## Section 2: Massing and Architecture

2201 N PERSHING DRIVE

**2201 N Pershing Dr  
History of Density/Massing Reductions**

1 AERIAL CONTXT PLAN ALONG NORTH PROPERTY LINE

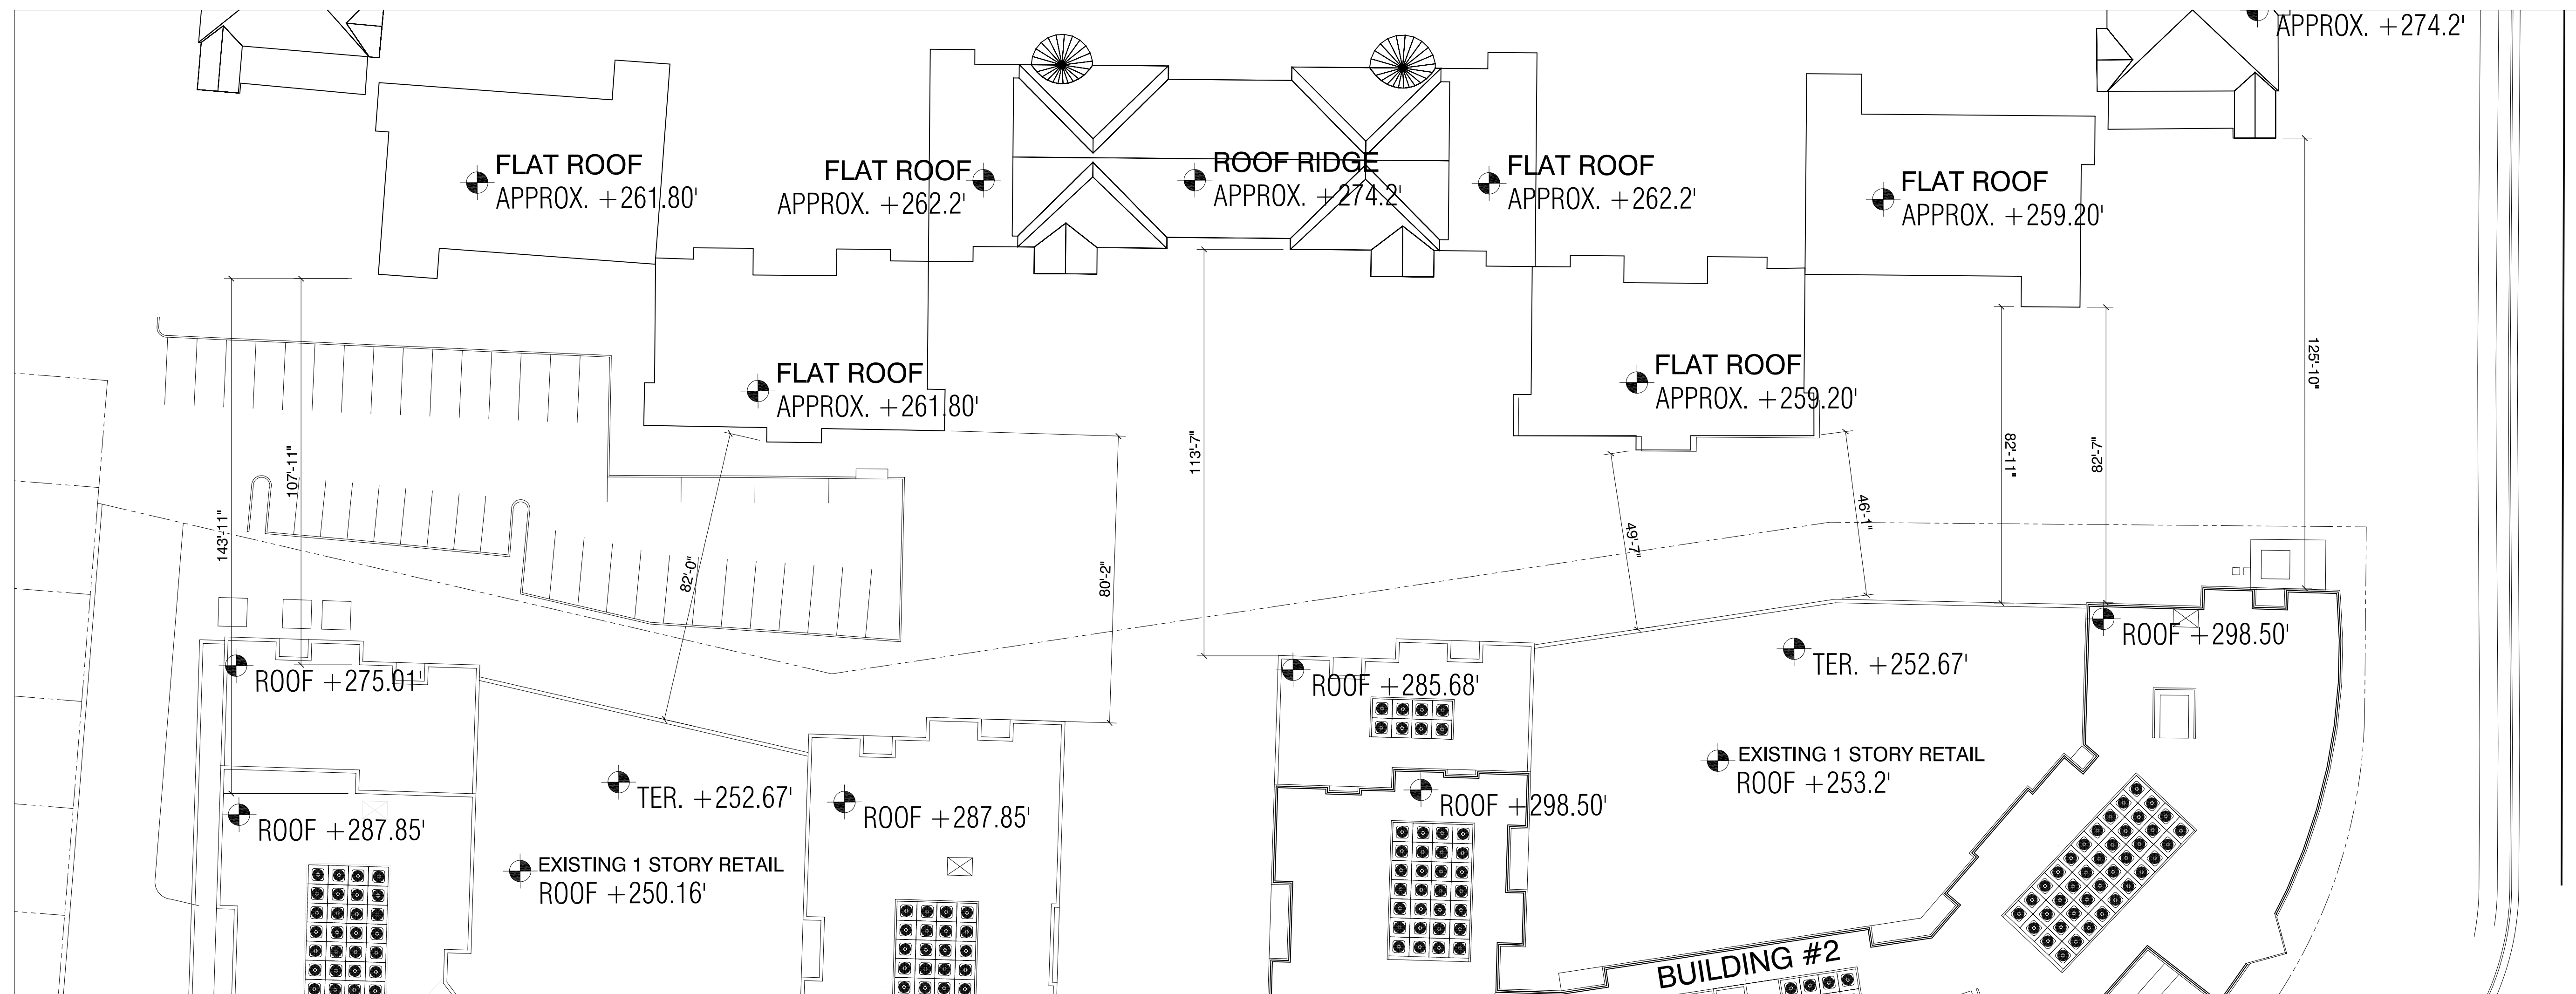
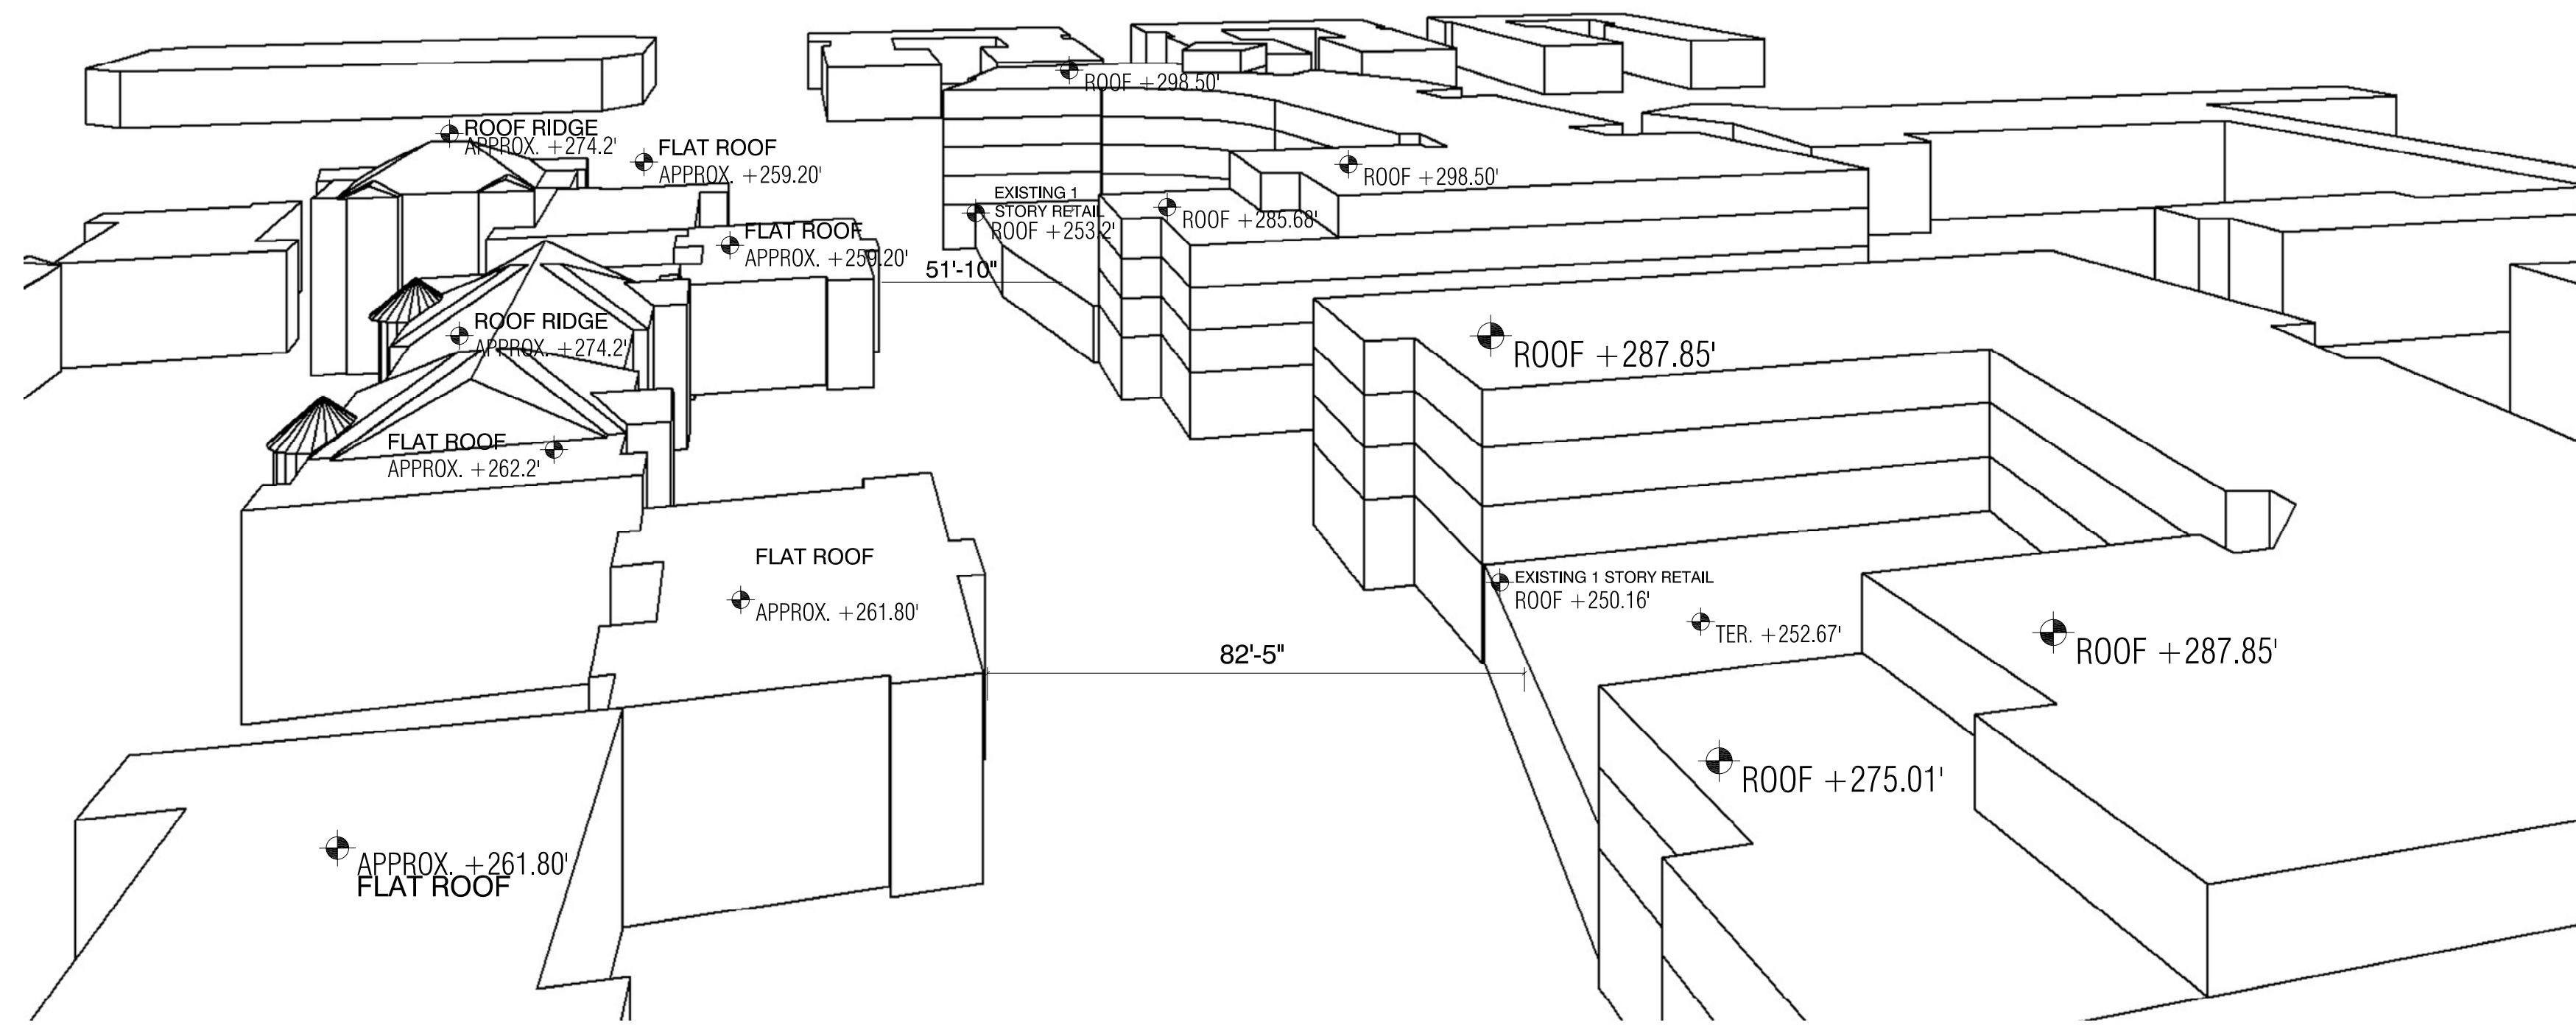
**What is the height of the project relative to Sheffield Court?** Sheet A8-1 shows proposed building heights relative to Sheffield Court along the north property line. In general, Sheffield Court's roof elevations vary between 261 and 274 feet. The proposed courtyards will be at 252 feet, approximately the same height as the roof elevations of the current Lee and Duron Centers. The residential roof heights will then vary between 275 and 298.5 feet in this area.

**Could the project be tapered to the north and west?** Yes. As stated above, the residential was set back off of the retail base along the western elevation, and tapering was also introduced along the north property line where the site adjoins Sheffield Court.

① ELEVATION DETAIL BLDG #2

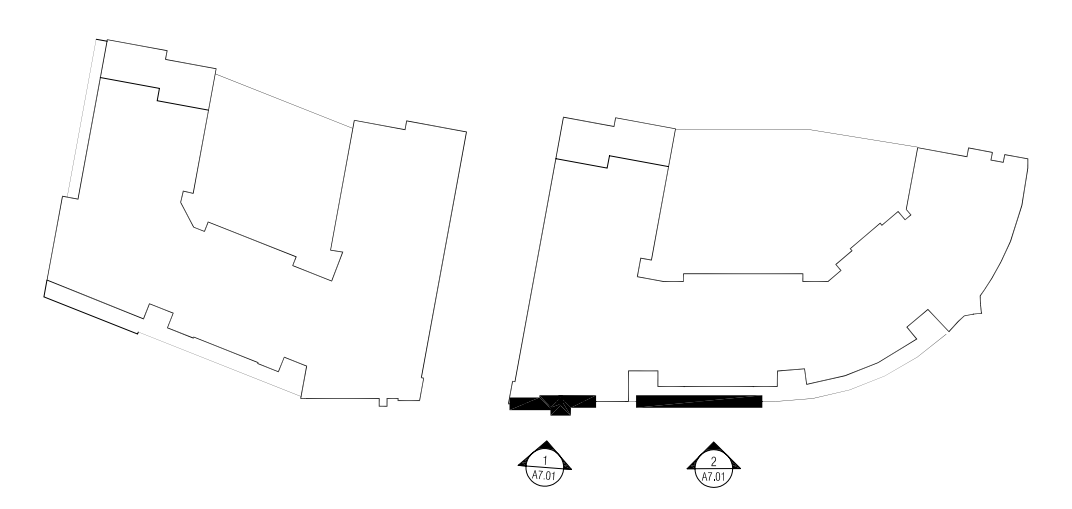
**What are the materials to be used on the façade?** Sheet A7-1 provides material callouts.
